## NOTICE TO ALL FIRMS

Re: Addendum Number 3  
IFB # C1585 – Pomerantz New Fire Alarm System

PROJECT: POMERANTZ DESIGN CENTER  
FIRE ALARM SYSTEM  
300 7TH AVENUE NEW YORK, NY, 10001

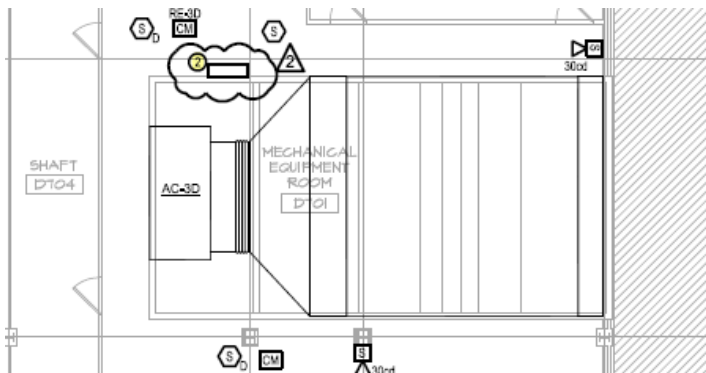
Q2. Drawing FA-107 keyed note#2 states that the contractor shall remove the existing oversized pull box and provide a new ceiling mounted field fabricated pull box to accommodate existing wiring. At the site walk through we did not have the opportunity to visit this floor and see the work, please give us the following information:

- What are the dimensions of this existing pull box and what will the new dimensions of the new?
- What does this existing pull box house; how many wires and what type of wiring is in this pull box?
- Will there be any requirement for temporary power for this transition?
- Will there be any requirements for Fire Watch for this Transition?
- Can you send us photos of this existing pull box and the space?

A2a. The box dimensions must be verified in the field but is approximately 80"H x 36"W x 18"D

A2b. The box contains fire alarm wiring. Two circuits.

A2c. Temporary power may not be required.

A2d. Fire watch will not be required.

A2e. The photo is as follows (box in question is the left large box)

CELLAR  
FIRE ALARM  
PLAN

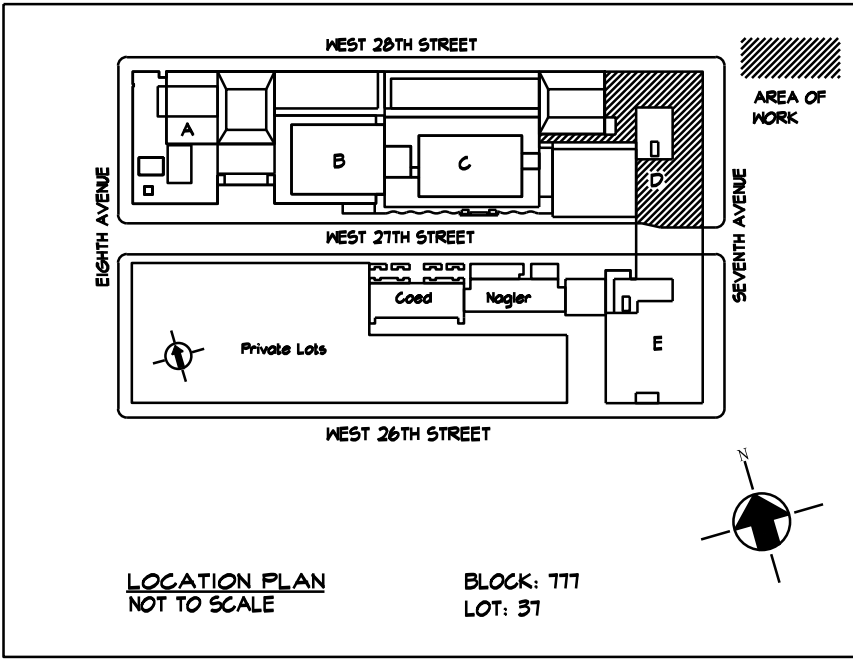
Q1. Information for the Elevator Vendor is provided to us via addendum#2, but we are interested in getting more clarification as to what is the Elevator Vendor responsibility of work regarding this new fire alarm system if it is not shown on the fire alarm drawings?

A1. Elevator recall relays and area smoke detectors (which trigger elevator recall) are being provided in elevator machine rooms GHC16 (cellar) and D702 roof all labelled with "EL". Addendum #3 amended drawings FA-100, FA-107, and FA-601 are provided for labeling clarification ("EL").

1ST FLOOR  
FIRE ALARM  
PLAN

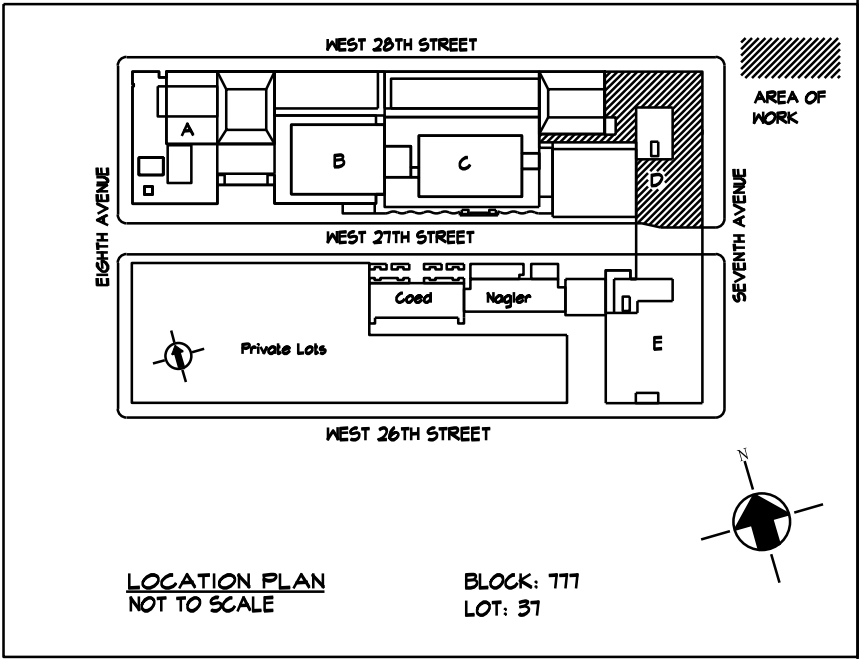
- Q3. Drawing FA-101- Working Notes #2 states that the contractor shall provide new wiring to reconnect to all devices fed from the existing Great Hall FACP, which is being removed as part of this project to the New DGP-1 located in the lobby and refer to riser diagram in the FA-600 Series, according to FA-601 drawing it shows FACP-GH8 existing and the wiring between this FACP-GH8 - DGP-1 is existing to remain.
- Please advise us how many circuits are to be transferred to the new DGP-1 unit.
  - Demo drawing FA-901Key notes#4 states that the existing FACP to remain, including all fire alarm device circuitry, there's no mentioning of removal or providing new circuits to the existing devices, please advise.

A3a. The Great Hall FACP is existing to remain. Drawing FA-101 has been amended as part of this Addendum #3.
